**CITY OF ISLE OF PALMS, SOUTH CAROLINA
REQUEST FOR BIDS (RFB) 2024-07
CONSTRUCTION OF 26A and 36A BEACH ACCESS BOARDWALK QUESTION
AND RESPONSES- September 18th, 2024**

BOARDWALK-H/C PARKING
52ND AVENUE
CITY OF ISLE OF PALMS

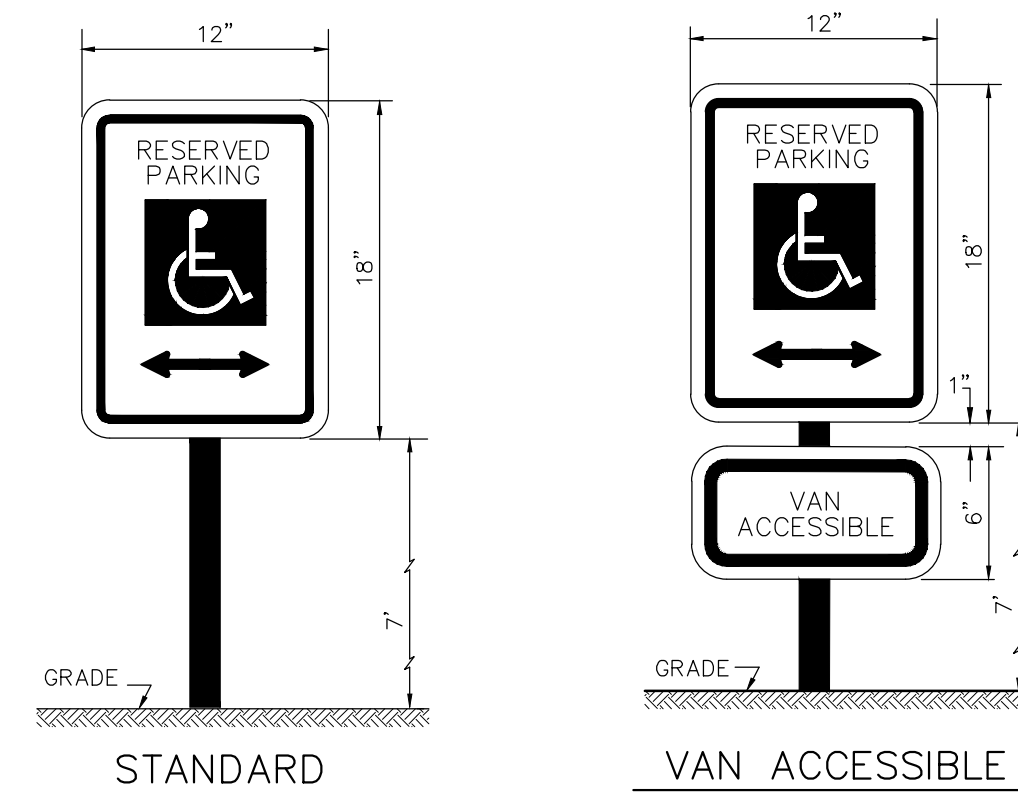
7. Are the trees in the path to be gone around or removed? If removed, is it the contractor's responsibility or the town's?

The trees will be required to be worked around.

4
L2
BOARD WALK PLAN WITH HANDRAIL AND BENCH
NTS
BOARDWALK
NOT TO SCALE

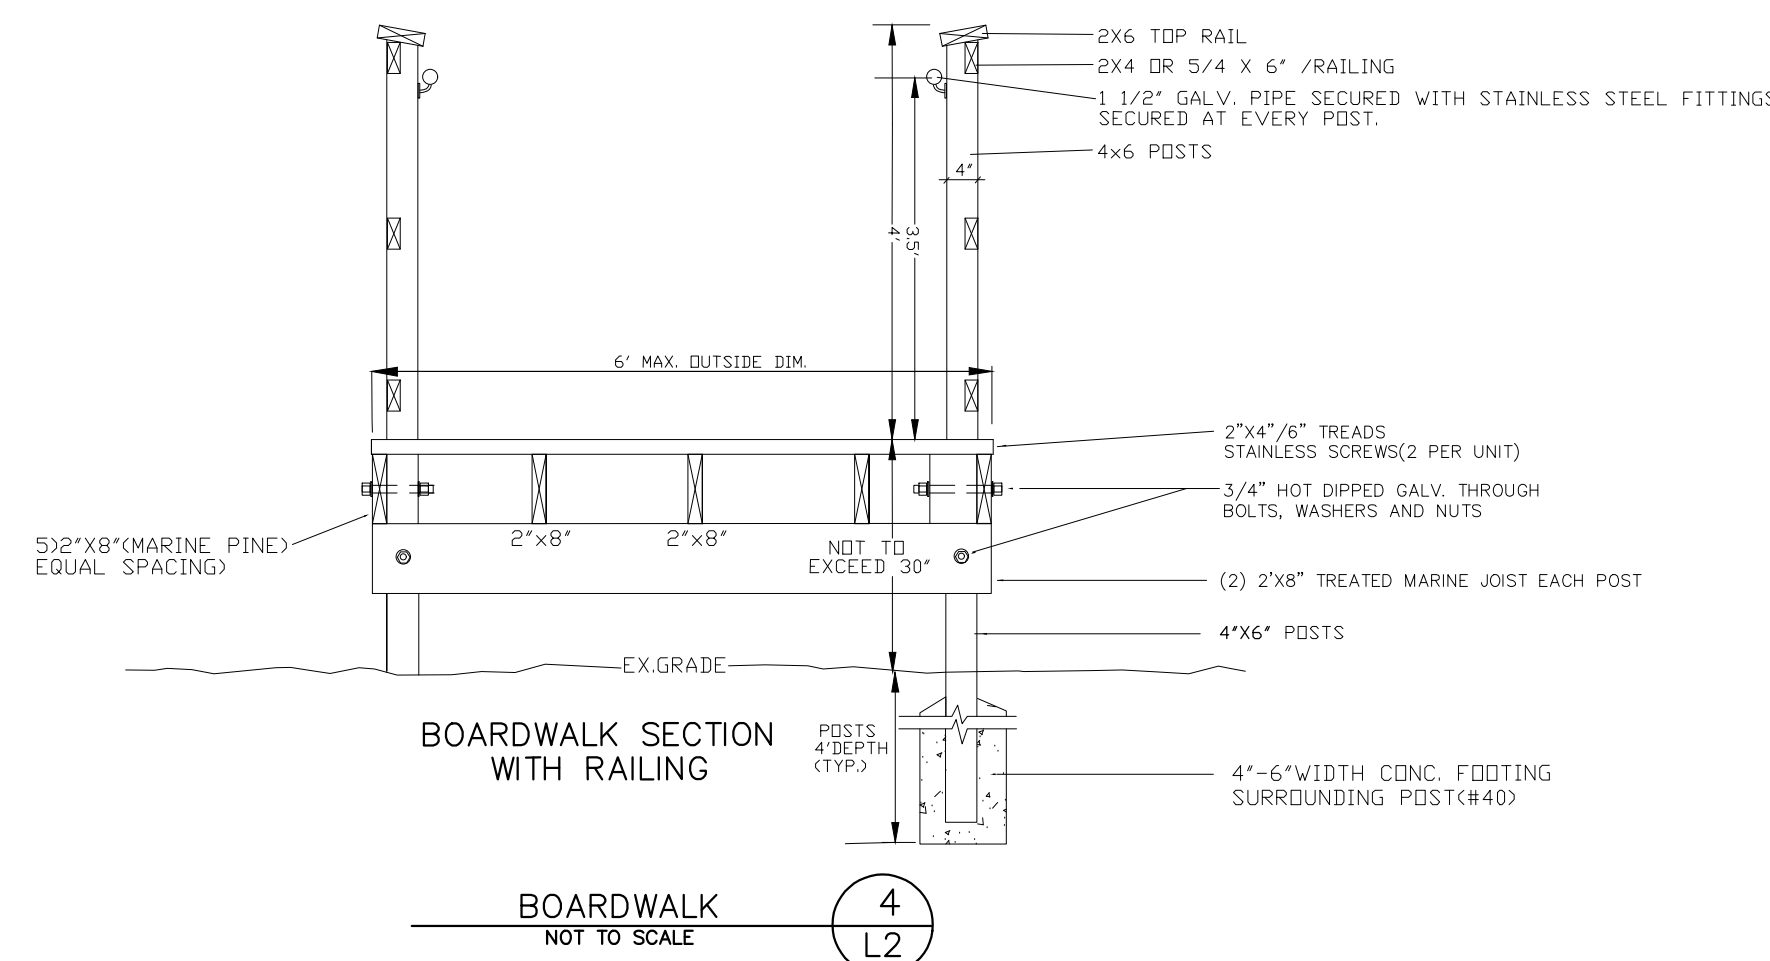
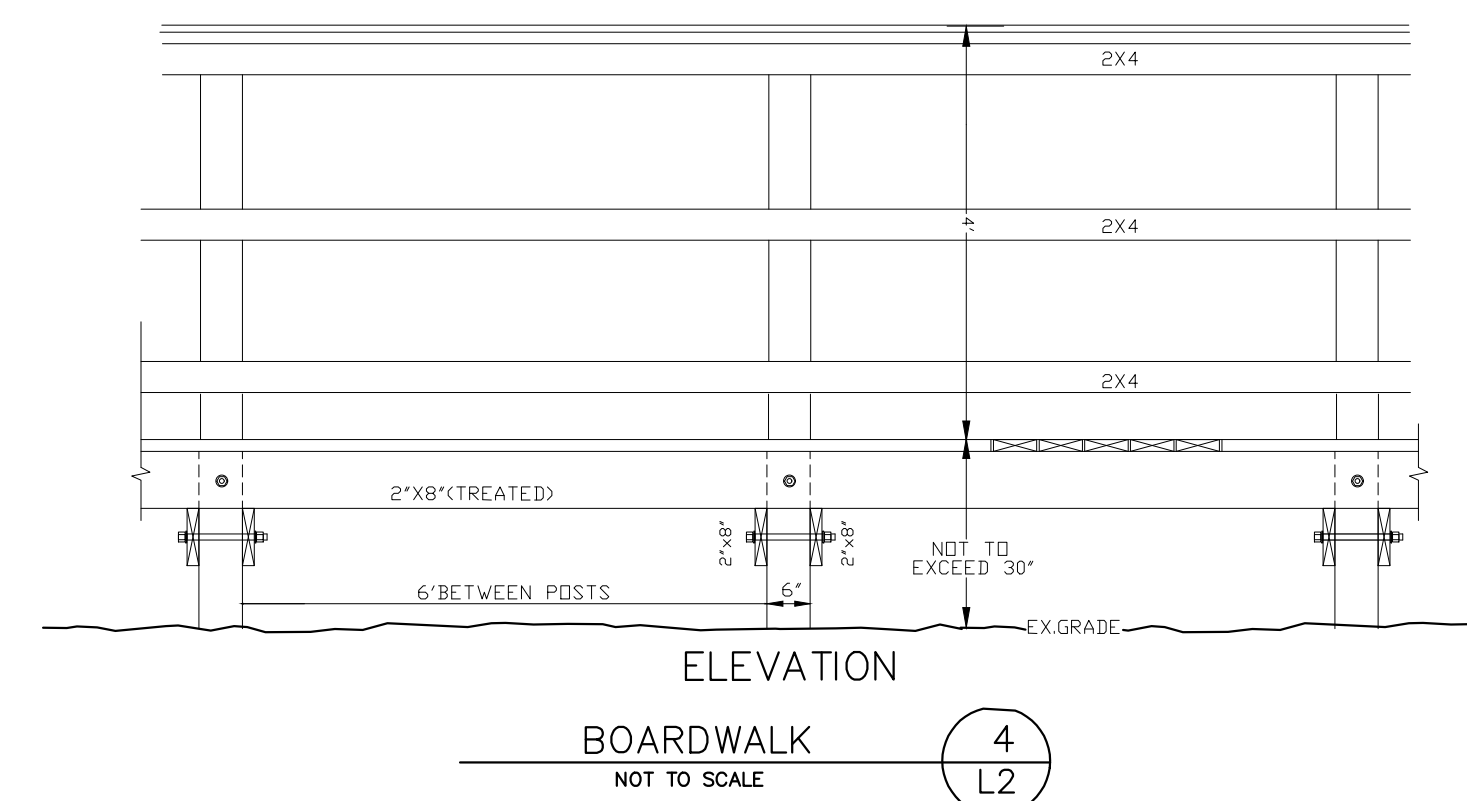
1. Is there a specific handrail detail or description?

3. Are there areas other than the stairs estimated to require handrails?

See page L2 (attached) for handrail details.

Any areas higher than 30" above the grade will need handrails.
